VISION PROFILE EXTRUSIONS

Sample Approval Form

Die #: 4683C
Description: 3-1/4" Operable Casement Frame

Die #: 4685C
Description: 3-1/4" Fixed Casement Frame

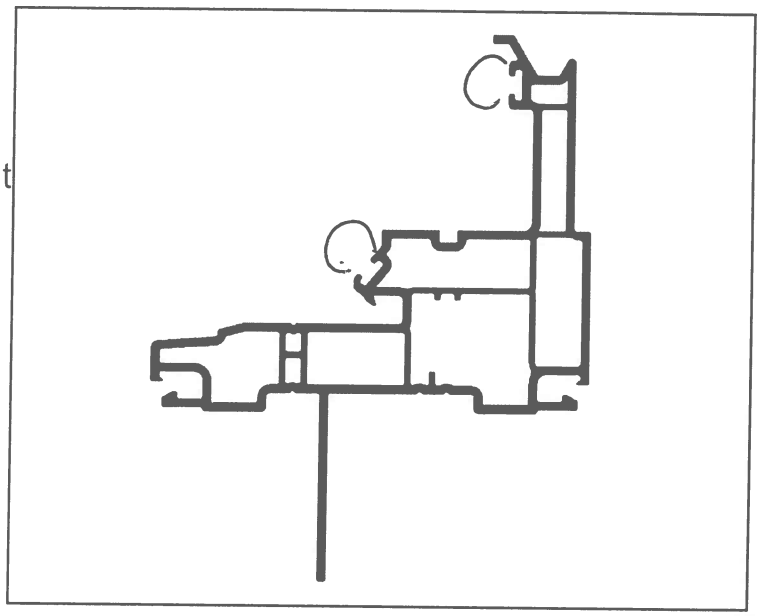
Comments: Comments emailed on 11/15/21, with response on 11/23/21. Though the sample did not have capstock, we are presuming this profile can be capstocked as shown on the prints.

2. Operable frame (4683):
   a. Fin is correct length and properly located off the front face of the profile.
   b. Overall exterior dims look good.
   c. The cavity in the tower is a little undersized. This is important b/c there is a support horn we slide into the cavity for punching the operator & locks. With that said, this sample did fit on the dies.
   d. I noticed the coex bulb was not extruded on these samples. For production runs we will need to ensure that this coex bulb is applied to both places indicated in the drawing.
   e. Though the vertical webs are a little skewed btwn cavities 1-3, the foam inserts fit, and these are comparable to what we see now.

2. Operable casement frame (4683)
   a. Please note typical fin tolerances are +/- 0.050
   b. Ok
   c. I will make note of this area to be no less than 0.840 which is still working in your punch
   d. Matthew explained about the situation, the flex posts are being modified to accommodate the fin.
   e. We will continue to monitor with the foam gauges we made last time we ran into issues.

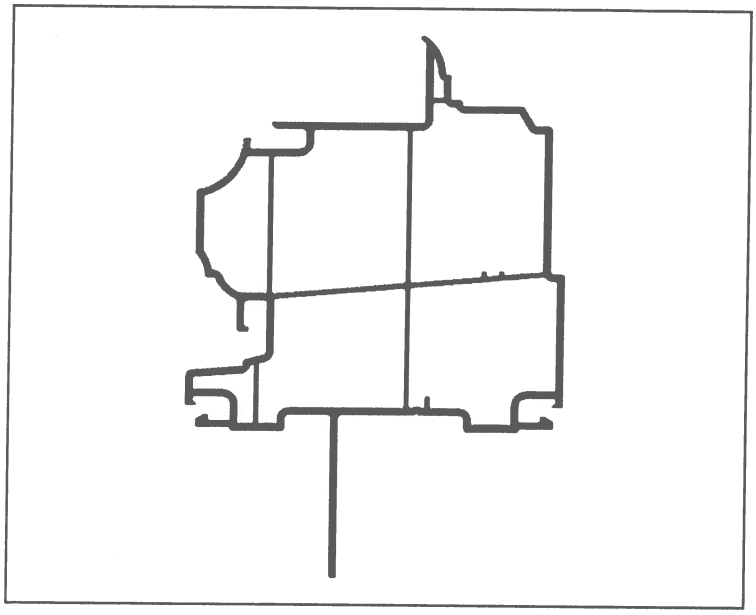
Comments: Comments emailed on 11/15/21, with response on 11/23/21. Though the sample did not have capstock, we are presuming this profile can be capstocked as shown on the prints.

1. PWCMT (4685):
   a. Fin is correct length and properly located off the front face of the profile.
   b. The height of the profile (without fin) was -.025" under nominal, and the overall height with fin was -.040" under nominal.
   c. The horizontal wall of the glazing pocket is pitched back towards the glazing tower by a degree.

d. I realize that internal webs & cavities are always difficult. With that said I wanted to comment on what I found. I numbered the five primary cavities, and cavity #1 was undersized, as well as one dimension from cavity #4. With that said, the foam inserts did fit in all cavities. This is simply something to keep an eye on.
e. I noticed that the web btwn cavity 1 & 5 has a defect. The vertical web fractured from the corner to the weep slot when punched. However, even on the unpunched piece I was noticed this web was already cracked. So I think there is an existing hairline fracture from the extruding process.

1. Fixed Casement Frame (PWCMT) 4685
   a. Please note typical fin tolerances are +/- 0.050
   b. The tool was cut using the same program as the older tool, we noticed on the older no fin tool it was also short -0.020. We will try to improve this area and should also increase as we run & tool wears in.
   c. We will look into this during production but at a +/- 1 degree it is currently acceptable
   d. We will maintain internal webs as straight as possible, Can you provide us the foam dimensions so we can cut gauges to check these cavities during production.
   e. We can take a closer look and have them polish this area before anodizing which should correct this issue.

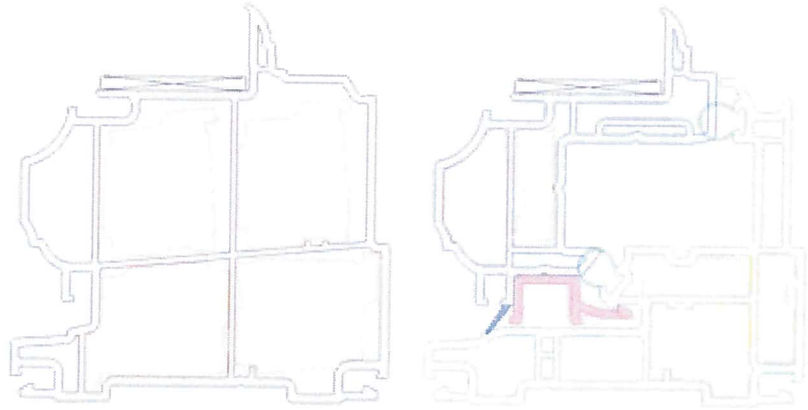
Good morning. Thank you for your response. Attached is the AutoCAD file for our foam inserts used in the csmt platform, and the screenshot below shows where they go.

The only follow-up comment that I have concerns the tolerance on the fin. Though this is the first time we have had you extrude a frame for us with an integral fin, I honestly thought that the length tolerance would be your standard ±.010" (or at worse ±.012") since it is an external feature. Could you please explain why the tolerance band is so large? Is there any way to tighten this? My concern is our fixturing. We modified our saw fixturing such that we can run both the Amerivu and Lighthouse Csmt platform through the same saw. However, to be able to cut 4685C, we have max'ed out the blade stroke (as this is the tallest profile we have), and the modification for the fin forced us to cut into the base plate supporting our fixtures. The clearance groove is total of .030" past the nominal fin length, and we cannot make the clearance groove for the fin any deeper without adversely affecting the integrity of the base plate. I would honestly like to keep the fin length tolerance at no more than +.020". Is that possible?

The fin varies a lot compared to the solid area and the tolerance is also accounting for punch slot locations.
The higher tolerance is to allow variation from either being too thick, too thin or too wavy.

We mostly see fins on the shorter side and on occasion we have to run it longer if its too thin.
I will add the +0.020 as an upper tolerance for them to monitor during production.
